GEORGETOWN WATERFRONT PARK

STAFF RECOMMENDATION

NCPC File Nos. 6383

May 26, 2005

COMMISSION APPROVED PLAN OF SEPTEMBER 2004

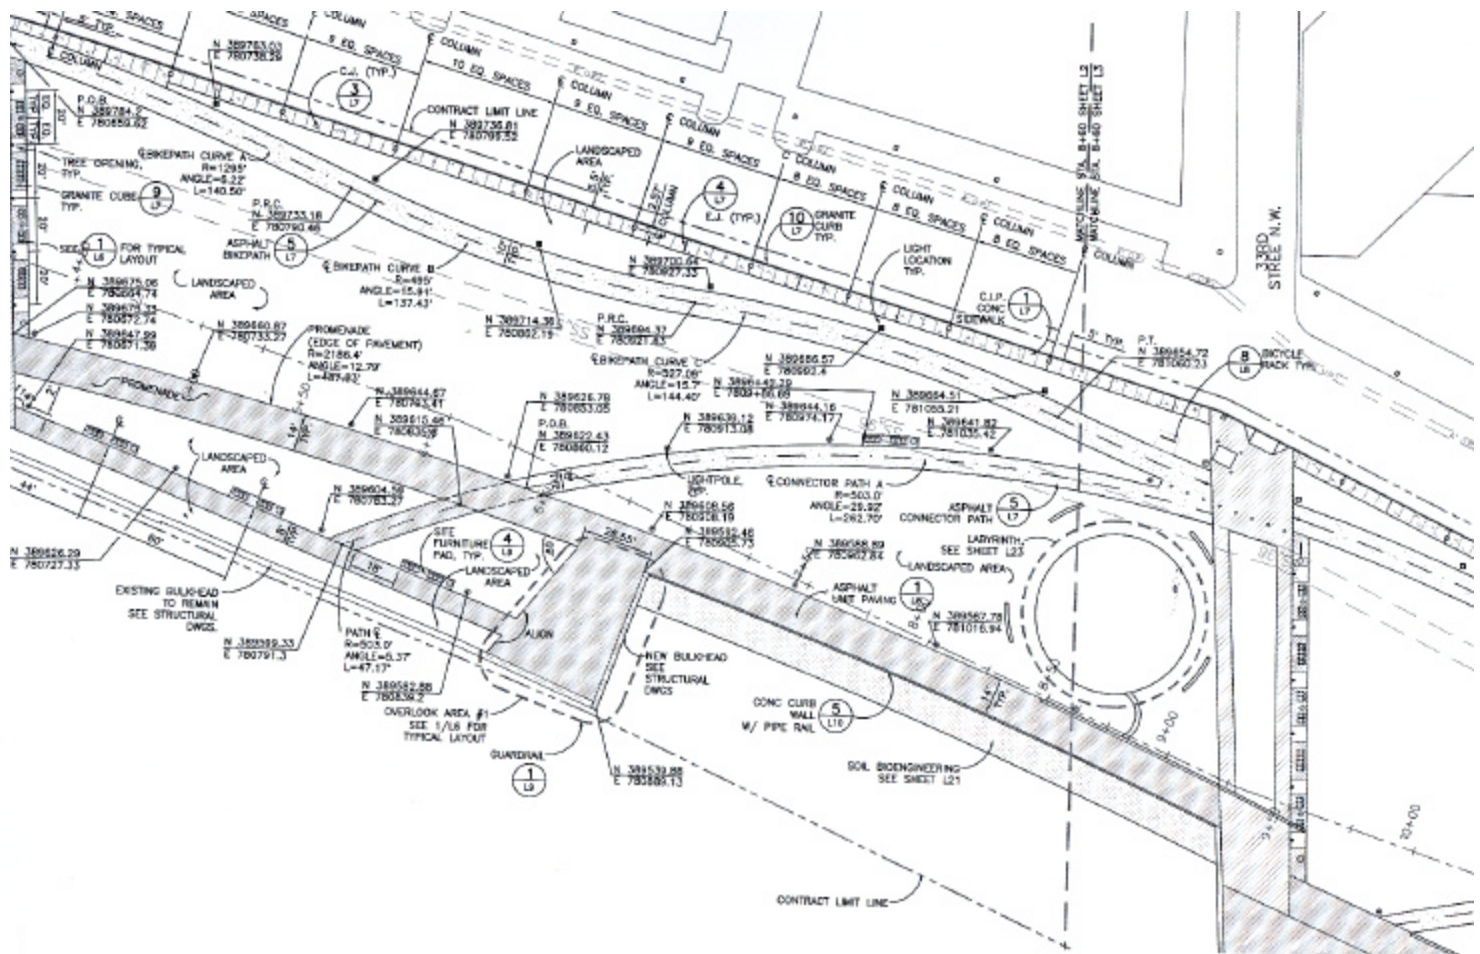
The submitted plan responds to the Commission's request to simplify paving materials within the park.

The final landscape design for the majority of the park area has been simplified to better transition and refine elements of the whole composition.
